## 2.2.4 AMENDMENT 13: CPH

### East elevation corrected to show retail duct route

APPROVED ELEVATION  
Drawing: 19557-CPA East Elevation

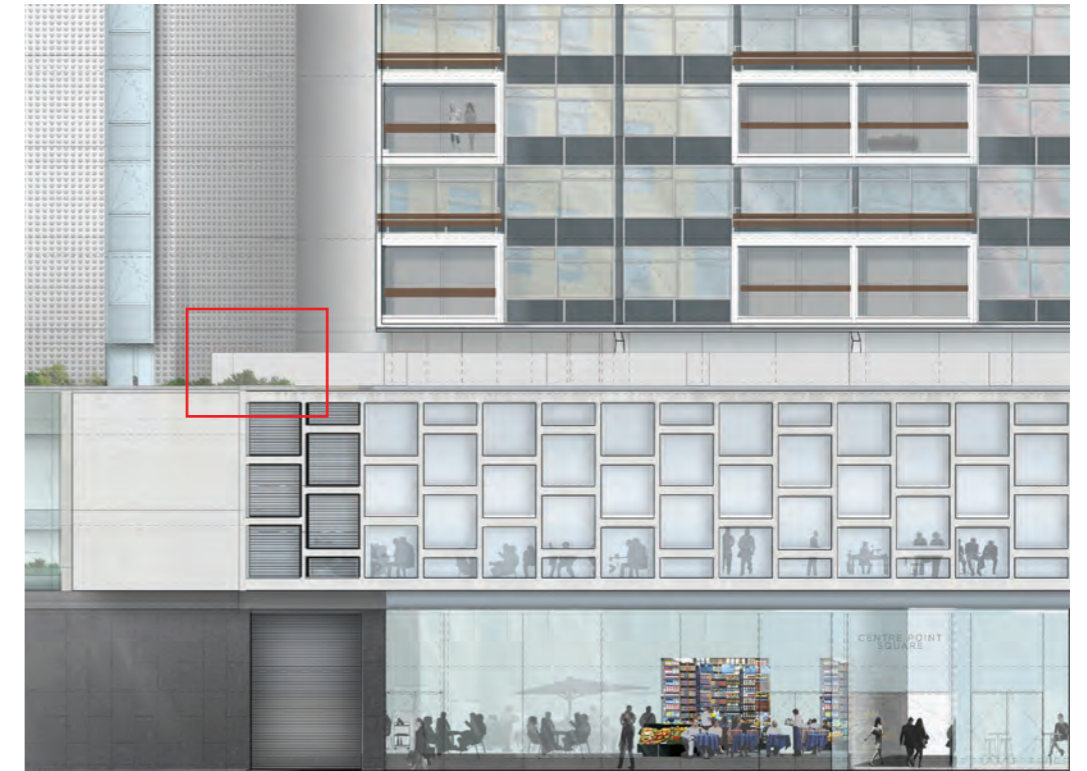
In the permitted drawings there is an inconsistency on the East elevation (drawing 552-19557-CPA) which does not reflect the full extent of the ductwork route shown on the approved level 02 plan. The elevation has been corrected to show the ducts continuing into the CPW plant riser area as per the plan layout.
